STELLANTIS PARTS & SERVICES

Technical Service Bulletin (TSB)

Global Telematics Box (TBM) Update To SW 4.39 - Dealer Option

REFERENCE:	**TSB:** 08-380-26 **GROUP:** 08 - Electrical	**Date:**	October 17, 2026	**REVISION:**	—
VEHICLES AFFECTED:	**2025 (WD) Dodge Durango** **This bulletin applies to vehicles equipped with Global Telematics Box Module (Sales Code RDG).**			**MARKET APPLICABILITY:** ☒ NA ☐ MEA ☐ SA ☐ IAP ☐ EE ☐ CH **NOTE: This bulletin applies to the North America market.**	
CUSTOMER SYMPTOM:	**Customers may experience a Malfunction Indicator Lamp (MIL) illumination and one or more of the following Diagnostic Trouble Codes (DTCs):** • B22A9-96 - ECU Internal Performance-Component Internal Failure. • B1560-11 - Cellular Antenna 1-Circuit Short To Ground. • B1560-13 - Cellular Antenna 1-Circuit Open. • B1561-11 - Cellular Antenna 2-Circuit Short To Ground. • B1561-13 - Cellular Antenna 2-Circuit Open. • B1562-14 - GPS Antenna-Circuit Short To Ground Or Open. **Customers may also experience the following:** • "Uconnect Box Requires Service" Message in Radio Display Fig. 1.

Fig. 1
Uconnect Box Error Message

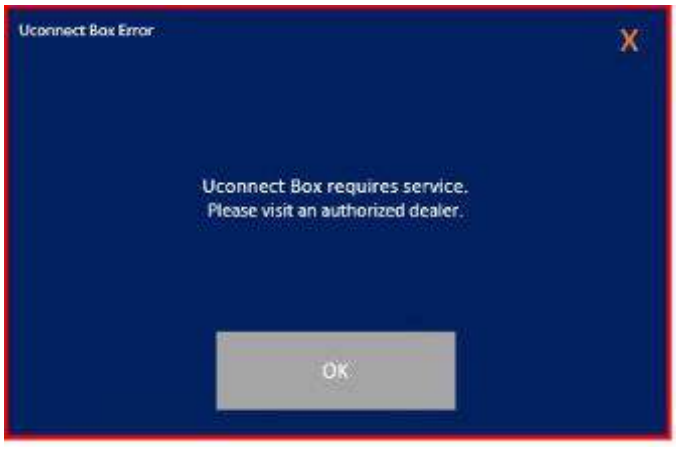
CAUSE:	**TBM Software**

This bulletin involves reprogramming the TBM with the latest available software.

1. Reprogram the TBM with the latest available software. If issues arise when flashing a module using the wiTECH Diagnostic Application, please submit a ticket to the Helpdesk. The helpdesk can be found within the Help menu.
2. Clear any DTCs that may have been set in any modules due to reprogramming. The wiTECH application will automatically present all DTCs after the flash and allow them to be cleared.
